APPLICATION NO.	FILING DATE	FIRST NAMED INVENTOR	ATTORNEY DOCKET NO.	CONFIRMATION NO.
10/588,536	08/07/2006	_		9569
Armstrong Westerman and Hattori 502 Washington Avenue			EXAMINER	
			FULTON, KRISTINA ROSE	
Suite 220 Towson, MD 21204			ART UNIT	PAPER NUMBER
,			3673	
			MAIL DATE	DELIVERY MODE
			08/06/2008	PAPER

Application No.	Applicant(s)			
Office Action Comments	10/588,536	GAROFOLI, FERNANDO			
Office Action Summary	Examiner	Art Unit			
	KRISTINA FULTON	3673			
The MAILING DATE of this communication app Period for Reply	ears on the cover sheet with the c	orrespondence address			
A SHORTENED STATUTORY PERIOD FOR REPLY IS SET TO EXPIRE 3 MONTH(S) OR THIRTY (30) DAYS, WHICHEVER IS LONGER, FROM THE MAILING DATE OF THIS COMMUNICATION.  - Extensions of time may be available under the provisions of 37 CFR 1.136(a). In no event, however, may a reply be timely filed after SIX (6) MONTHS from the mailing date of this communication.  - If NO period for reply is specified above, the maximum statutory period will apply and will expire SIX (6) MONTHS from the mailing date of this communication.  - Failure to reply within the set or extended period for reply will, by statute, cause the app

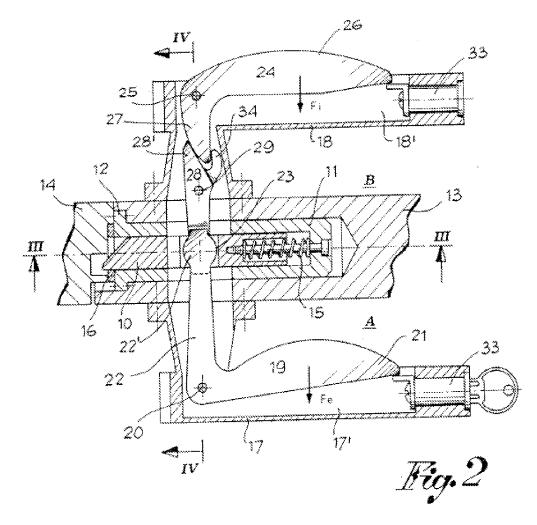
Claims 1-15 are rejected under 35 U.S.C. 102(b) as being anticipated by Pedersoli (DE4009764). "As best understood" Pedersoli shows internal and external handles (17 and 18) having an opening lever (22 or 27) and an opening button (26 or 21). The handle further include a vertical lever (28) having a fork (29). The device includes a spring (15) within a housing (11) and a latch mechanism (10). The door handle further shows a cylindrical chamber (at each end of handle for cylinder 33). The handle includes a cylinder (33) for locking the handle with a key (see illustration below). The handle is an L shape. See the Pedersoli device below.
